Our Ref: 18BGC02B2: NVD/JT
Council Ref: DA2017/0388
RFS Ref: D17/2229

**Re: Bushfire assessment in support of a Section 4.55 application
8 Narabang Way, Belrose**

Travers bushfire & ecology has been engaged to prepare an updated bushfire protection assessment to assess the BAL levels applicable for the proposed industrial development at the above address.

In particular this assessment seeks to amend the following Conditions 3 – 6 provided by the NSW RFS via their letter dated 28th July 2017.

Figure 3 – South & North Elevations

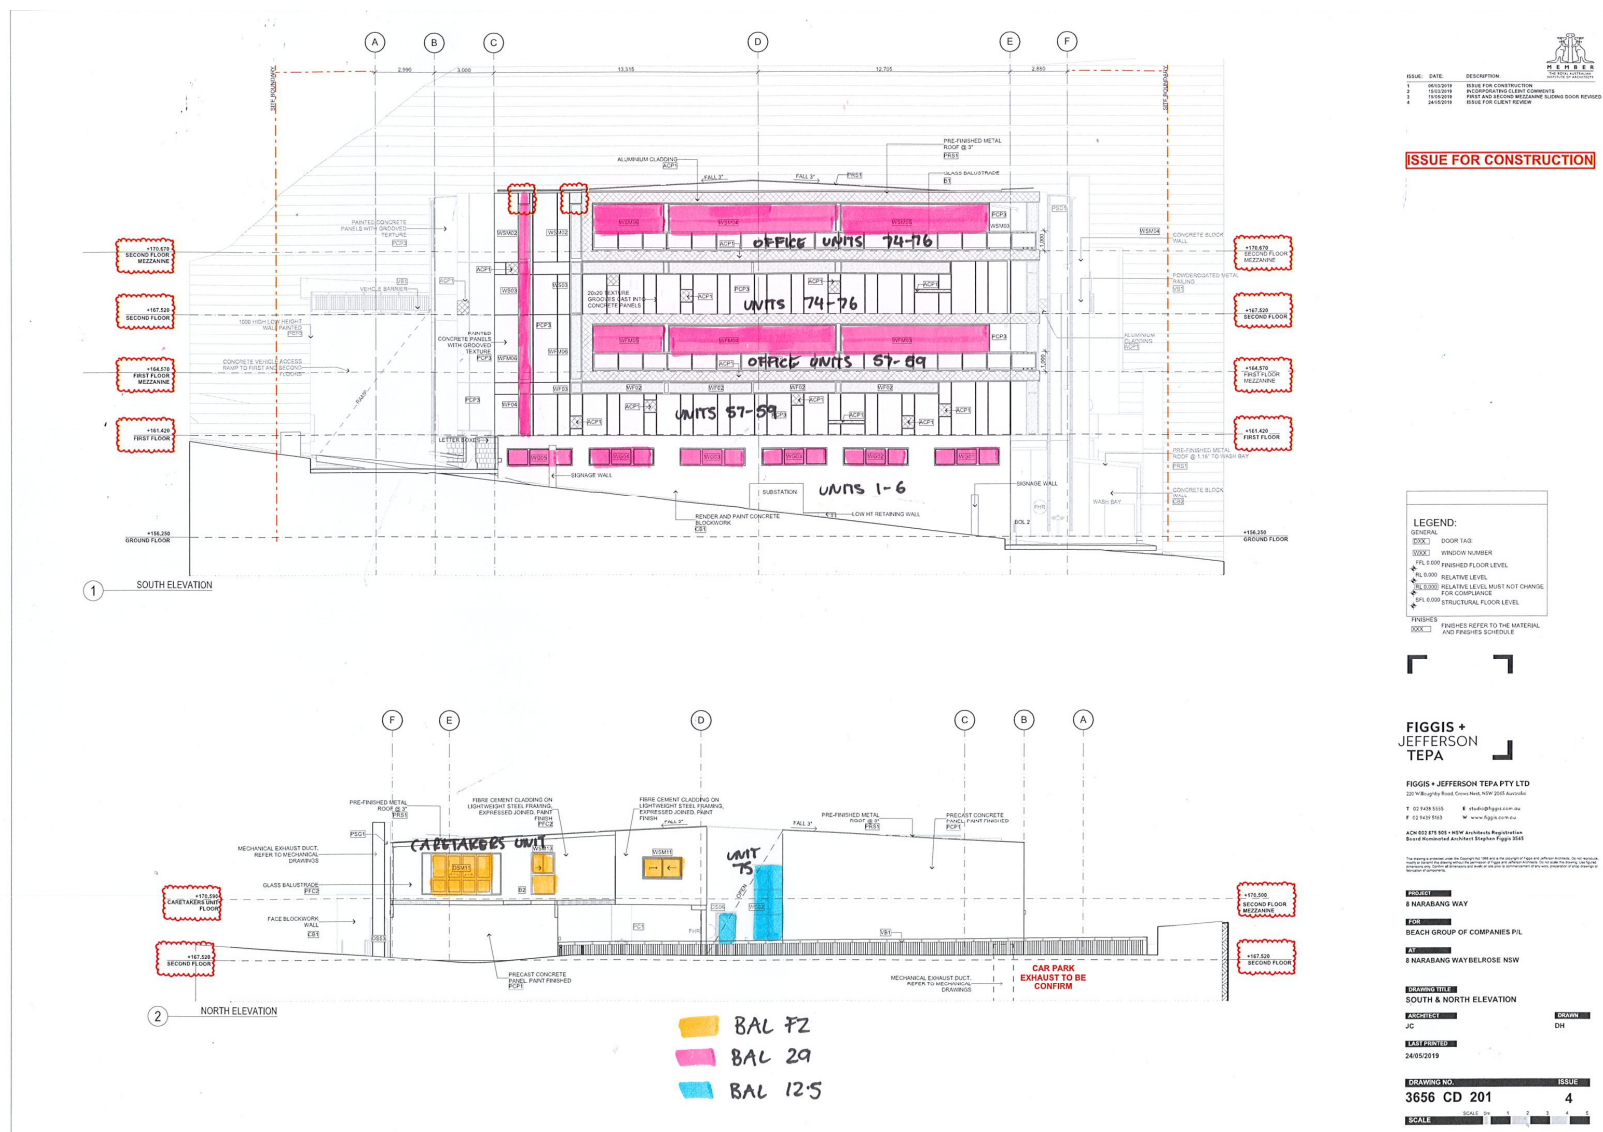
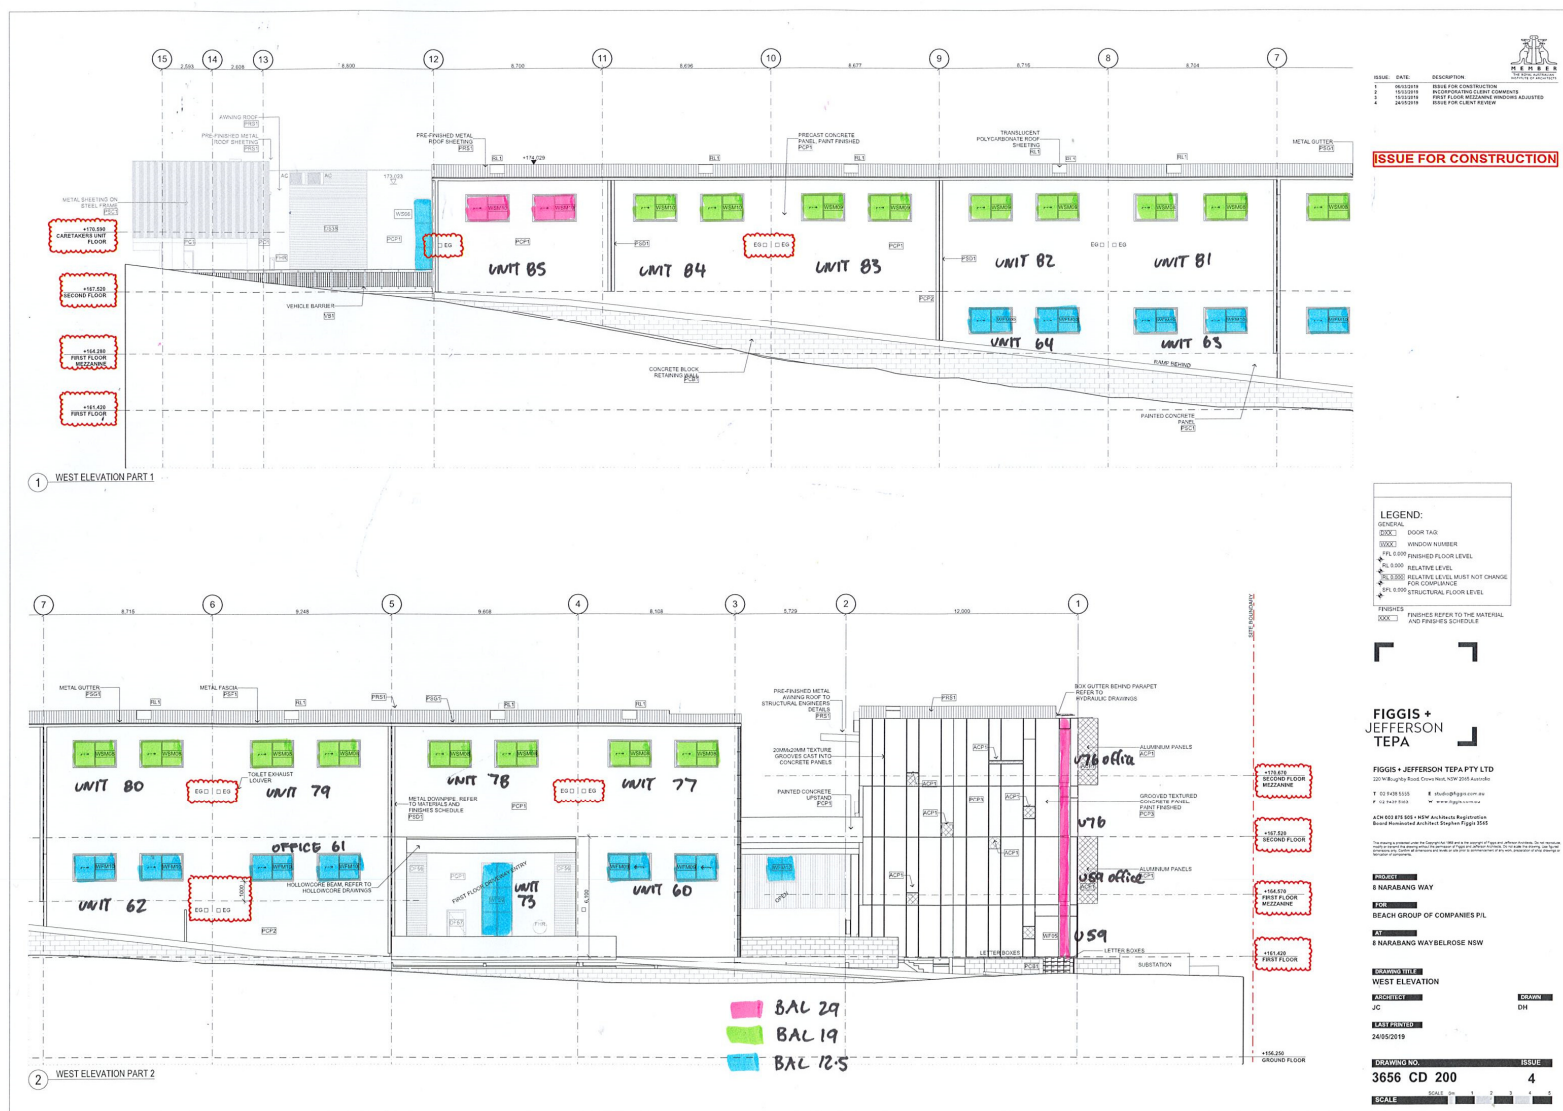
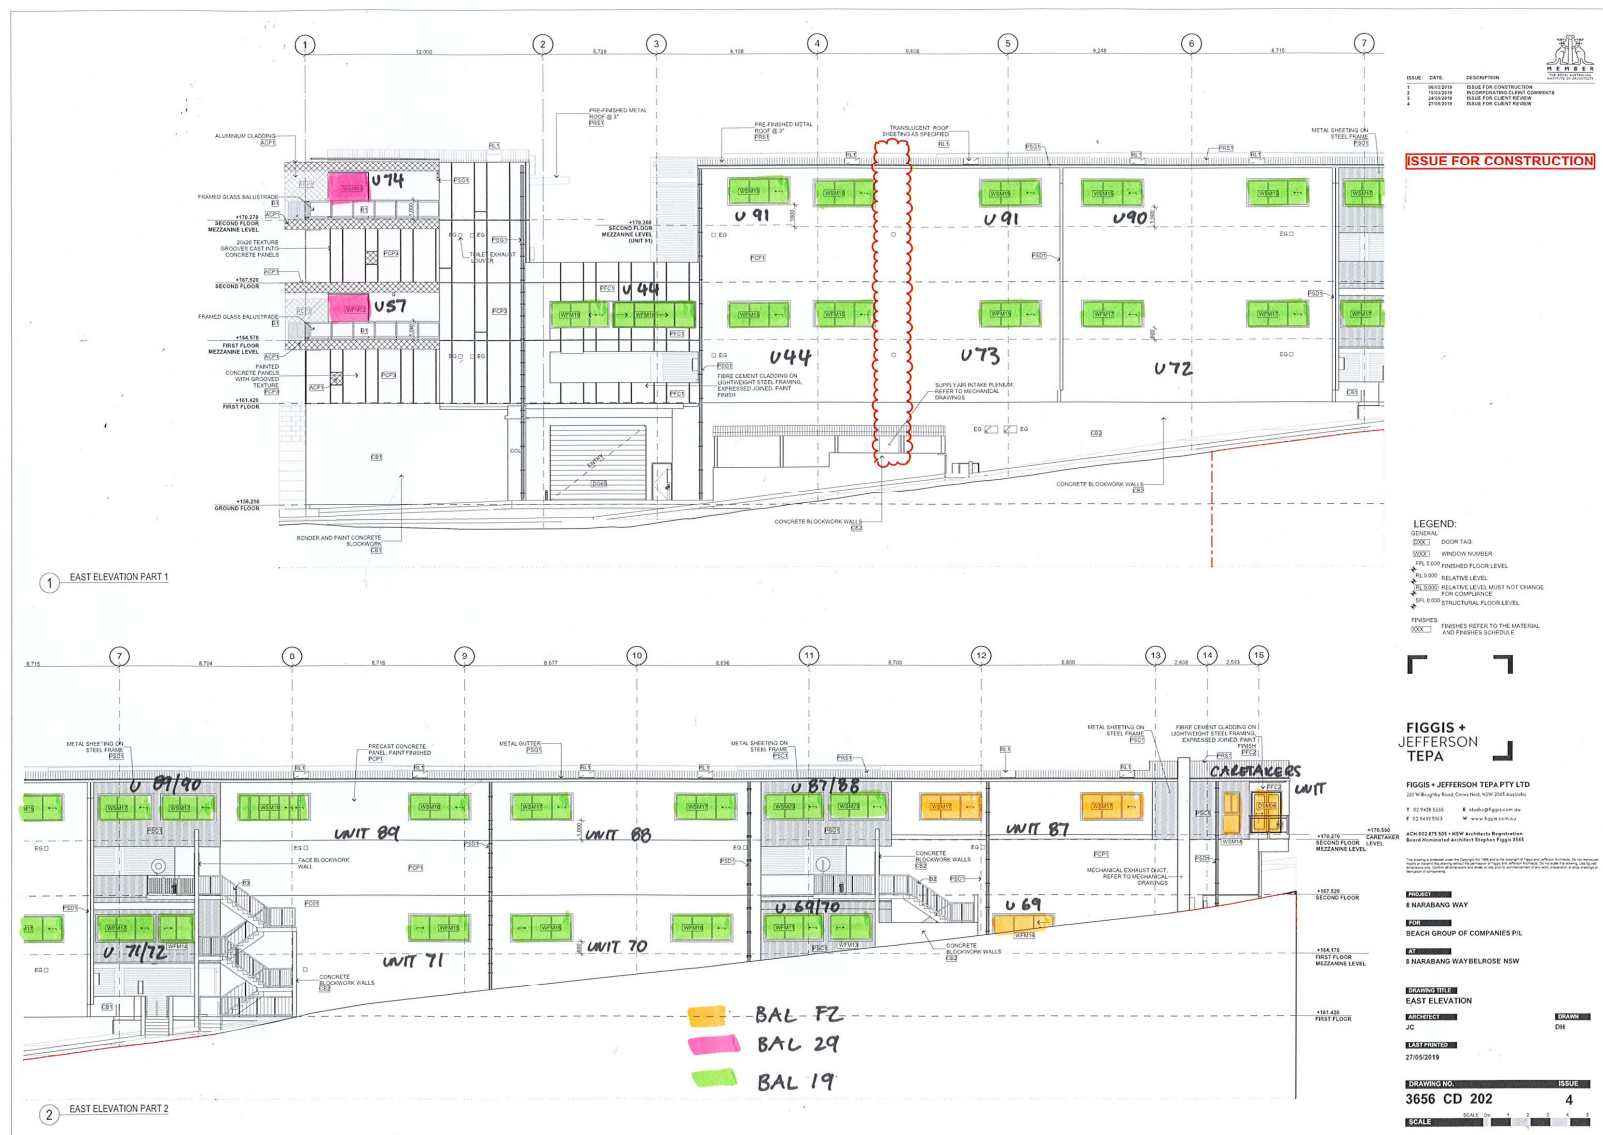
The most vulnerable parts of the industrial building in terms of bushfire impact are the roof, windows and doors and therefore the BAL ratings outlined in Table 7 (and depicted in the following figures) should apply to the units. In addition a BAL 29 rating is to apply to the roof of Building A & Building B. BAL FZ applies to the caretakers Unit & Unit 87 with the remainder of the building roof complying with BAL 29 (refer Schedule 1 attached).

The following changes to the current conditions are recommended and are to apply only to the external windows / doors (not to the internal windows / doors);

Condition 3 – The northern external elevation of the building, including the **Caretakers Unit and the eastern elevation of Unit 87 & 69** ~~Units 66, 67, 68, 69, 70, 84, 85, 86, 87 & 88~~ shall comply with Section 3 and 9 (BAL FZ) of Australian Standard AS3959 – 2009....

Condition 4 – The external elevations of the adjoining units **44, 87 – 91, 70-73, 77-84** ~~64, 65, 71, 82, 83 & 89~~ shall comply with Section 3 and **6 & 8** (BAL **19 40**) of Australian Standard AS3959 – 2009....

Condition 5 – The southern external elevation of the building, including Units **1 – 6, 57, 58, 59, 60, 73, 74, 75 & 76, the eastern external elevation of the building including Units 57 & 74 and western external elevation of Unit 59, 76 & 85** shall comply with Section 3 and **7 & 8** (BAL **29 40**) of Australian Standard AS3959 – 2009....

Condition 6 – The remainder of the middle units **(external facades) on the second floor and the western external elevation, including Units 60-64** shall comply with Section 3 and **5 & 7** (BAL **12.5 29**) of Australian Standard AS3959 – 2009....

Condition 7 - The southern external elevation of the Caretakers Unit shall comply with Section 3 and 8 (BAL 40) of Australian Standard AS3959 – 2009....

In addition a BAL 29 rating is to apply to the roof of Building A & Building B. BAL FZ applies to the caretakers Unit & Unit 87 with the remainder of the building roof complying with BAL 29 (refer Schedule 1 attached).
